SERVICE BULLETIN #94-01

June 7, 1994

SUBJECT: Excessive wear of throttle ball swivel fitting.

MODELS AFFECTED: All Models SERIAL NUMBERS AFFECTED: All

Fig. 1

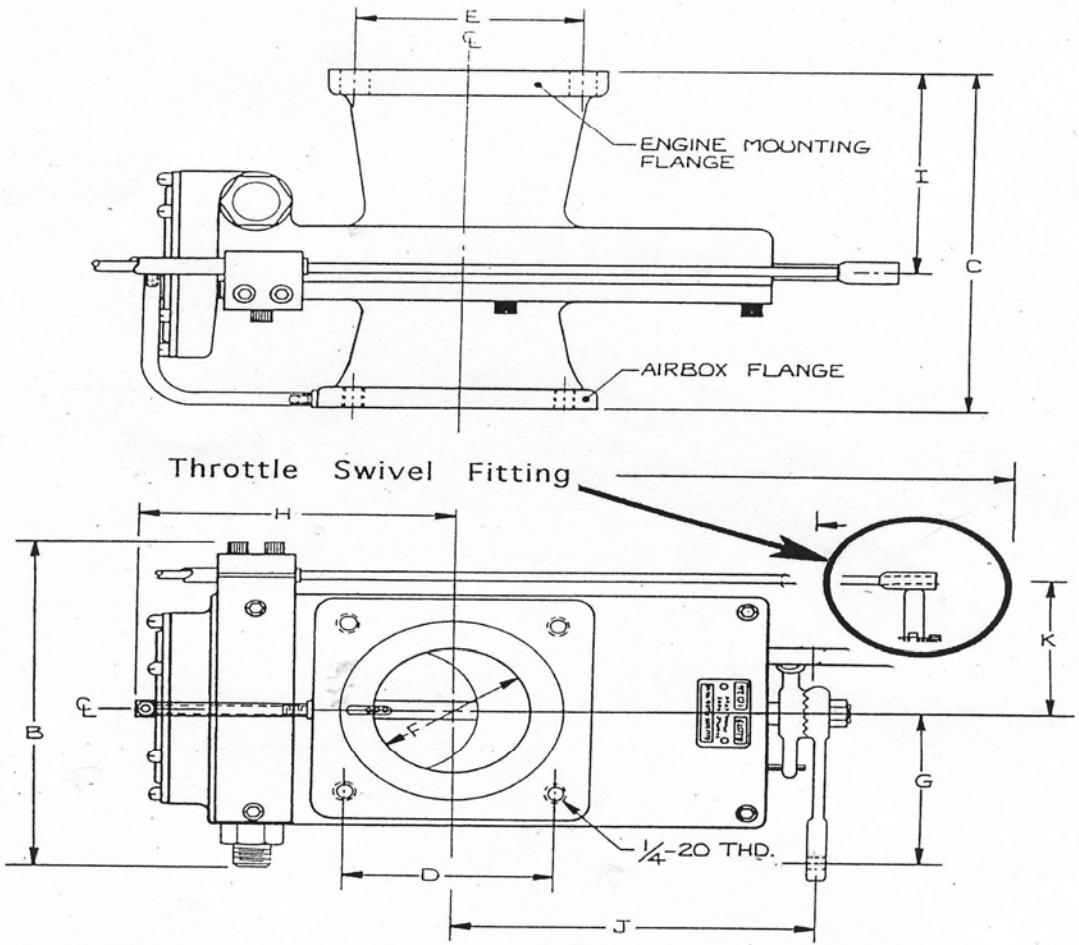
Ellison Fluid Systems, Inc. has discovered two instances of excessive wear of the ball swivel fitting which connects the throttle linkage to the Throttle body Injector throttle shaft. See attached Fig. 1 for location of the swivel fitting. These two worn fittings were found on aircraft with rod type throttle linkages. Inflight throttle linkage disconnect with resulting engine failure will occur if this wear continues uncorrected.

1. See figure 1 for the location of the swivel fitting.
2. Disconnect the ball swivel fitting from the throttle shaft by removing the snap ring and sliding back the spring loaded retention collar (see figure 2 and 3).

Fig. 2

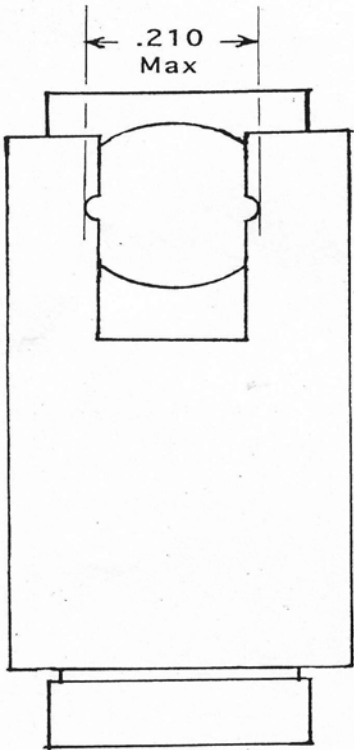
3. Examine the slot machined in the retention collar for wear. Figure 2 illustrates the wear caused by the throttle shaft and shows the maximum permissible wear caused by the throttle shaft. Figure 3 shows maximum permissible wear in the retention collar caused by the ball. If the swivel fitting is worn beyond either of the above specified limits, it must be replaced with a new fitting before further flight. This swivel fitting is P/N 14-003 and the spring clip is P/N 33-005; both are available from Ellison Fluid Systems, Inc.

Fig. 4

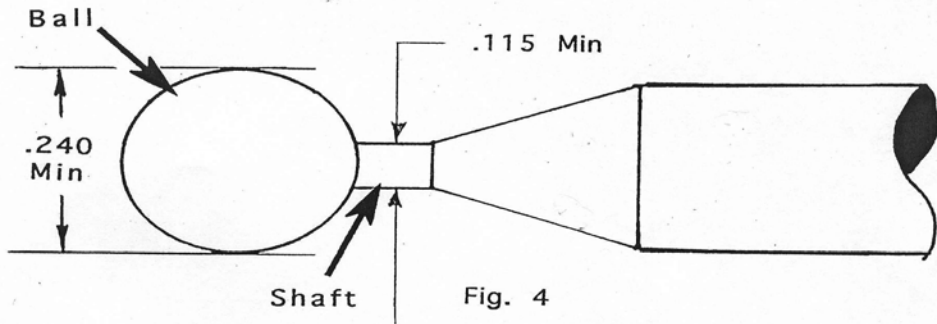
4. Figure 4 shows maximum permissible wear of the ball and throttle shaft. If either the ball or the throttle shaft is worn beyond the limits specified in figure 4, the throttle shaft of the injector must be replaced. This part is not field serviceable. For repair, please send the unit in to Ellison Fluid Systems, Inc. to the letterhead address.
